Access Compliance Report

Public Rights-of-Way (Curb Ramps)

Intersection ID: 17346	Main Street: DEVON_DR	Cross Street: WILLOW_OAK_RD	Location:	N
ADA ID: 54E8F5A420AA	Ramp Type: Directional2	Initial Pass/Fail: Pass	Overall Compliance: No	Severity Score: 0

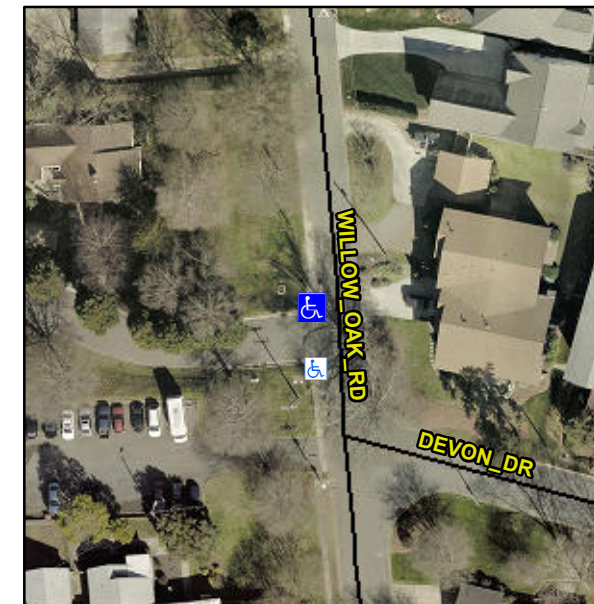
R304.2.1, R304.5.3

Compliance	Description	Data	Compliance	Description	Data
N/A	Ramp Length (in)	116.0	Yes	Grade Break?	Yes
Yes	Ramp Width (in)	48.0	No	Grade Break Slope (%)	7.0
Yes	Ramp Slope (%)	7.7	Yes	Grade Break XSlope (%)	0.5
Yes	Ramp XSlope (%)	0.9			
Yes	Flare Type LT	N/A	N/A	Flare Type RT	N/A
N/A	Flare Slope LT (%)	N/A	N/A	Flare Slope RT (%)	1.9
N/A	Flare Traversable LT?	No	N/A	Flare Traversable RT?	Yes
No	Landing Length (in)	46.0	Yes	DWS Provided?	Yes
Yes	Landing Width (in)	53.0	Yes	DWS Contrast?	Yes
Yes	Landing Slope (%)	1.7	Yes	DWS Length (in)	24.0
Yes	Landing X Slope (%)	4.1	Yes	DWS Full Width?	Yes
N/A	Landing Curb? (Y/N)	N/A	Yes	DWS Offset LT (in)	28.0
N/A	Shared Landing?	No	Yes	DWS Offset RT (in)	0.0
Yes	Gutter Ponding?	No	Yes	Gutter Slope (%)	3.4
Yes	Gutter Lip Ht (in)	0.0	Yes	Gutter X Slope (%)	2.3
N/A	Painted X Walk1?	No		Road Slope (%)	4.8
	X Walk 1 Direction	To SE		Road X Slope (%)	4.1
	X Walk 1 Width (in)	N/A		Clear Space?	Yes

Remove & Replace Entire Ramp.
